Informal document **GRSG-108-46-Rev.1**  
(108<sup>th</sup> GRSG, 4-8 May 2015,  
agenda item 5)

## **Proposal for a draft Supplement to the 04 series of amendments to Regulation No. 46 (Devices for indirect vision)**

### **Submitted by the expert from the Netherlands**

Figure 7  
~~Field of vision of Class IV wide-angle mirrors~~ **Class IV fields of vision**

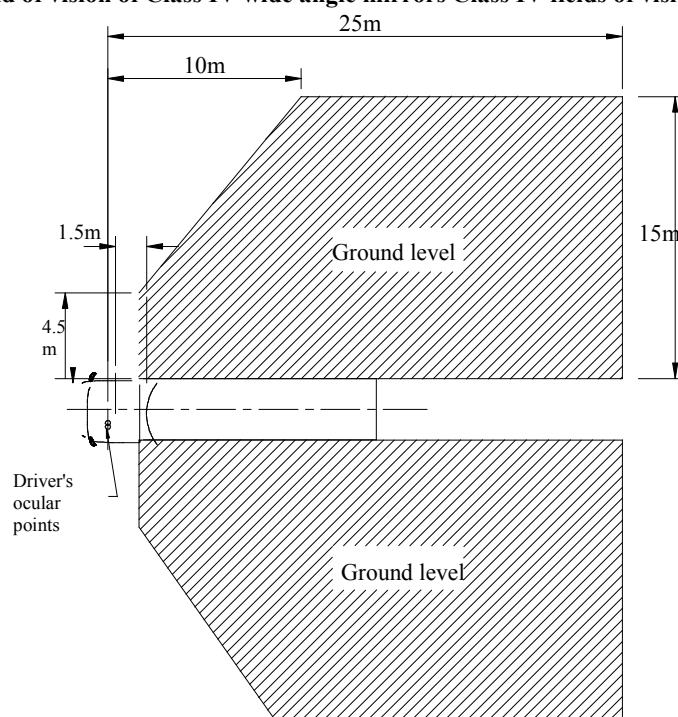
53. Paragraphs 15.2.3.1. and 15.2.3.2.  
These paragraphs specify that the provisions on adjustment apply only to mirrors.
54. Paragraph 15.2.4.4.2.  
Figure 7 has been corrected on the passenger's side so that the indicated dimensions are in correspondence with the front of the grey area.
